**NPDES PERMIT FACT SHEET  
ADDENDUM**

Application No. PA0091910  
APS ID 662600  
Authorization ID 1395672

Applicant Name	<u>Alex E Paris Contracting Co. Inc.</u>	Facility Name	<u>Paris Flyash Landfill</u>
Applicant Address	<u>PO Box 369 1595 Smith Twp. Street Road Atlasburg, PA 15004-0369</u>	Facility Address	<u>Frankfort Springs Road - Murdocksville Road Hookstown, PA 15050</u>
Applicant Contact	<u>Emanuel Paris</u>	Facility Contact	<u>Emanuel Paris</u>
Applicant Phone	<u>724-947-2235</u>	Facility Phone	<u>724-947-2235</u>
Client ID	<u>33092</u>	Site ID	<u>521850</u>
SIC Code	<u>4953</u>	Municipality	<u>Hanover Township</u>
SIC Description	<u>Trans. &amp; Utilities - Refuse Systems</u>	County	<u>Beaver</u>
Date Published in PA Bulletin	<u>May 28, 2022</u>	EPA Waived?	<u>No</u>
Comment Period End Date	<u>July 12, 2022</u>	If No, Reason	<u>Imposing TMDL Limits for the first time</u>
Purpose of Application	<u>Renewal of NPDES permit PA0091910</u>

### 3.0 MONTHLY AVERAGE FLOWS

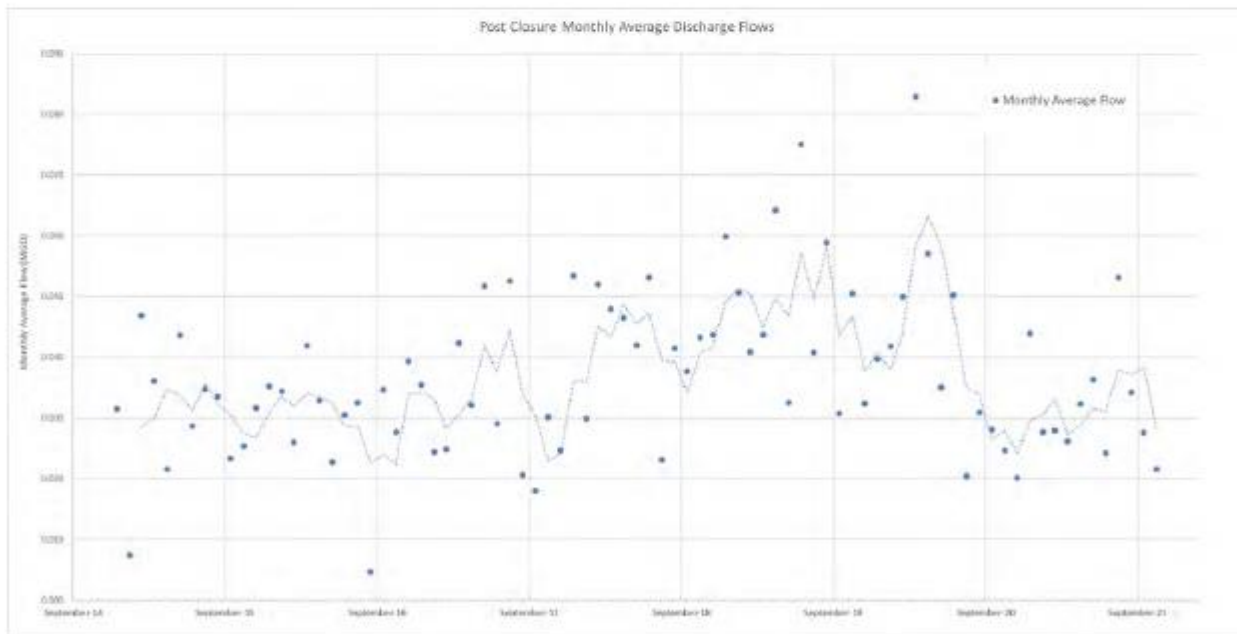
CEC reviewed monthly average leachate flow data for Outfall 001 from January 2011 to July 2022. Post closure monthly average flow data (January 2015 to July 2022) are shown in the following graph:

Long-term average and median average monthly flows for the entire monitoring period and the post-closure period were identical at 0.037 and 0.035 MGD, respectively.

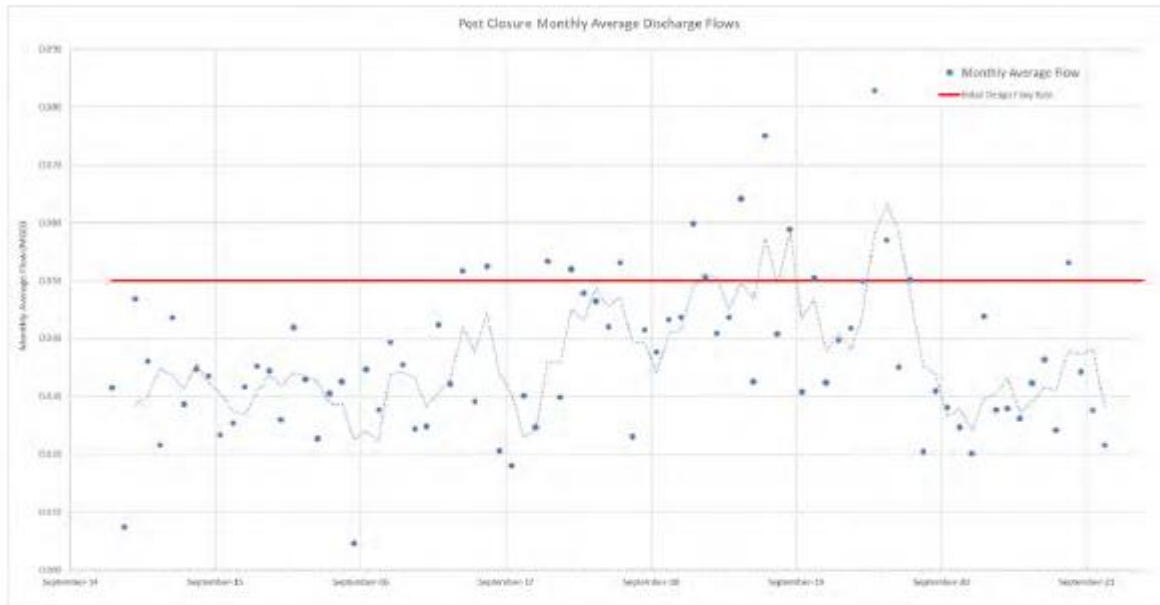
In order to assess the impact of a pumping system which could provide a more consistent flow from Outfall 001, CEC considered a flow of 0.05 MGD as an initial design discharge rate:

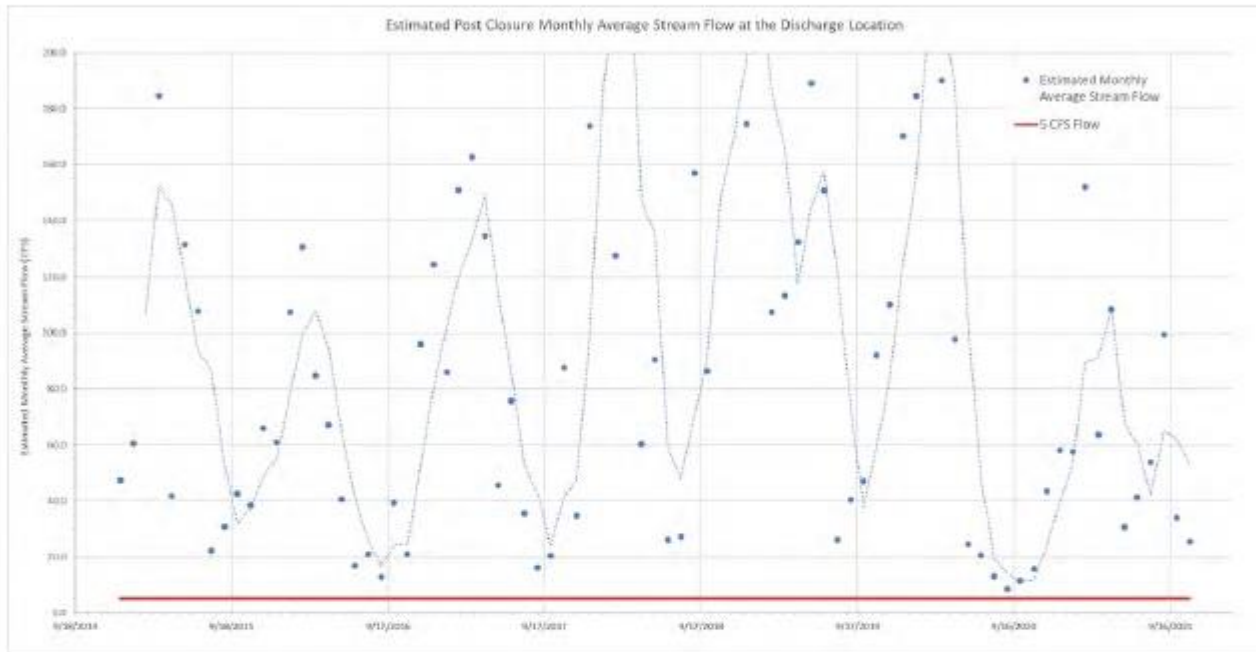
A minimum flow of 5 CFS relative to the estimated monthly average flows for Raccoon Creek is shown below:

As previously noted, the discharge from the closed facility is pumped with real time flow monitoring, and the discharge system includes a large basin, which can hold approximately 70 days of leachate production at the long-term average leachate discharge rate. Therefore, Paris has the ability to control the discharge rate, maintain the average discharge rate over extended time periods, and operate the holding pond with sufficient volume to hold leachate for an extended period of low flow in Raccoon Creek.

## 5.0 TOXIC MANAGEMENT SPREADSHEET MODELLING

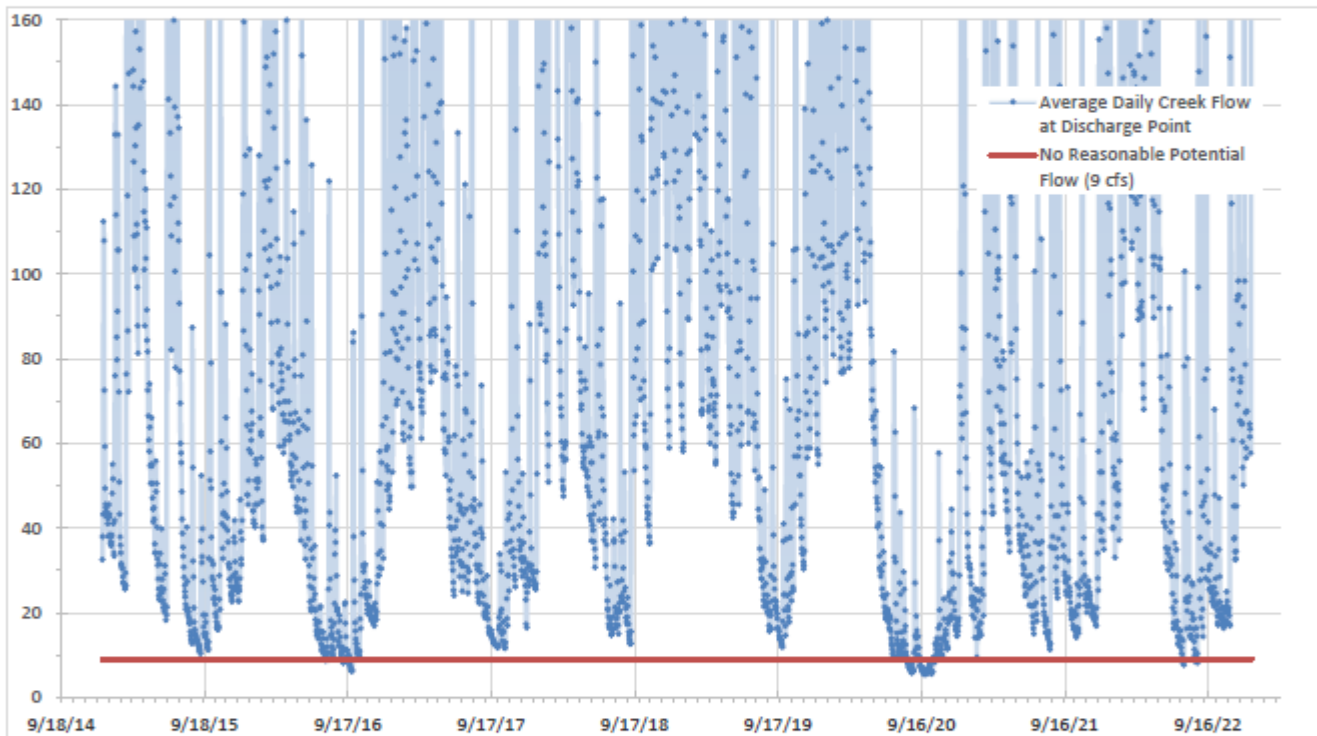
As noted in the code of federal regulations (CFR) for the enforcement of the Clean Water Act, 40 CFR 122.4 (d) (1)(ii) states that: *“When determining whether a discharge causes, has the reasonable potential to cause, or contributes to an in-stream excursion above a narrative or numeric criteria within a State water quality standard, the permitting authority shall use procedures which account for existing controls on point and nonpoint sources of pollution, the variability of the pollutant or pollutant parameter in the effluent, the sensitivity of the species to toxicity testing (when evaluating whole effluent toxicity), and where appropriate, the dilution of the effluent in the receiving water.”*

Using the PADEP’s Toxic Management Spreadsheet model, with the analytical data included with the original permit application and a discharge rate of 0.05 MGD in an iterative fashion, CEC calculated the stream flow which would be required to provide sufficient dilution to the boron loading from the

landfill discharge to achieve a no Reasonable Potential scenario. Based on the Toxic Management Spreadsheet, a 9 cubic feet per second (CFS) flow in Raccoon Creek at the discharge location would provide a situation in which there would be no reasonable potential for an exceedance of the boron water quality criteria. A printout for the Toxic Management Spreadsheet run is included in Attachment A.

The Department has reviewed the Revised Discharge Flow Assessment Report for the Paris Flyash Landfill and has determined that we cannot accept Civil and Environmental Consultants' solution to determining applicable water quality limitations on the discharge from the Paris Flyash Landfill.

CEC's solution incorporates a real-time management approach for achieving WQBELs by only discharging when the stream flow is large enough that when using in the Department's Toxics Management Spread Sheet, no limitations would apply to the discharge. In this scenario, Alex E. Paris Contracting Co., Inc. would hold the leachate in ponds until such a time that the stream flow was great enough to discharge.

However, the Department is willing to accept and re-evaluated the WQBELs in the Toxics Management Spreadsheet using the re-evaluated design flow from the report, 0.05 MGD. Using this discharge flow, the WQBELs are less stringent but Paris will still not be able to meet them upon permit issuance. Therefore, Paris will still need to evaluate the discharge and determine how it plans to achieve the new WQBELs. A few solutions that the Department would like to point out, other than installing treatment, would be re-routing the discharge to a point where the  $Q_{7-10}$  flow is great enough to handle the discharge or using a very reduced flow rate with additional storage.
